NORTH AMERICAN AVIATION, INC • MUNICIPAL AIRPORT • LOS ANGELES 45, CALIF.

NO. 20
JAN. 28, 1947

HARTZELL NO. 8628 PROPELLER BLADE TIP REWORK

FIGURE 1

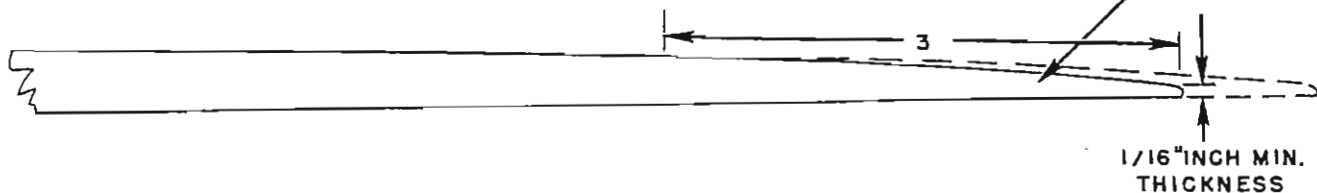
Tests on the propeller blades indicate that the propeller diameter should be reduced from 86 inches to 84 inches. This reduction in diameter should help prevent cracking of the blade tipping and loss of rivets.

2 REGRIND CAMBER SURFACE ONLY

3 WITH TIPPING REMOVED, SCRIBE LINE (BOTH SIDES OF BLADE) TO LOCATE HOLES. AFTER TIPPING IS INSTALLED DETERMINE EXACT LOCATION WITH DIMPLE PUNCH.

1 REMOVE OLD TIPPING TO THIS CUT.

4 ANCHOR TIPPING WITH TWO RIVETS AT THESE POINTS BEFORE PULLING DOWN OUTER SECTION OF TIPPING WITH SHOCK CORD.

5 THIN OUT TIPPING; UNDERLAP ON CAMBER SURFACE AND SWEAT-SOLDER.

1. Remove approximately 7-7/8 inches (to the break or file cut nearest 7-7/8 inches from the tip) of the outer section of the metal leading edge as follows:
 - a. Center-punch the rivet head on the face or thrust side of the blade. When center-punching, back the opposite side of the blade with flat metal block.
 - b. Cut out the head of the rivet with a 1/4-inch countersink or 1/4-inch drill, ground to 82 degrees.

2. Lay out and cut off blade tips:
 - a. Mark off one inch from tip of each blade.
 - b. Lay out shape of tip, using template made according to figure 1.
 - c. Cut off to the layout lines, and fair in the camber side of the blade as shown.
 - d. Recountersink the holes affected by the fairing operation to the same depth as the other holes.

3. Install new A86 metal tipping:
 - a. Mark off location of the holes as shown.
 - b. If holes in the blade are larger than $1/8$ inch, fill with plastic wood and redrill with $1/8$ -inch drill.

- h. Form the tip lap as shown before putting in the last two outboard rivets. Locate last rivet, which is $3/32$ inch in diameter. Drill and dimple the metal just slightly. The dimple may be improved by light countersinking. This rivet is to hold the loose end of metal from vibrating; a full head is not necessary.
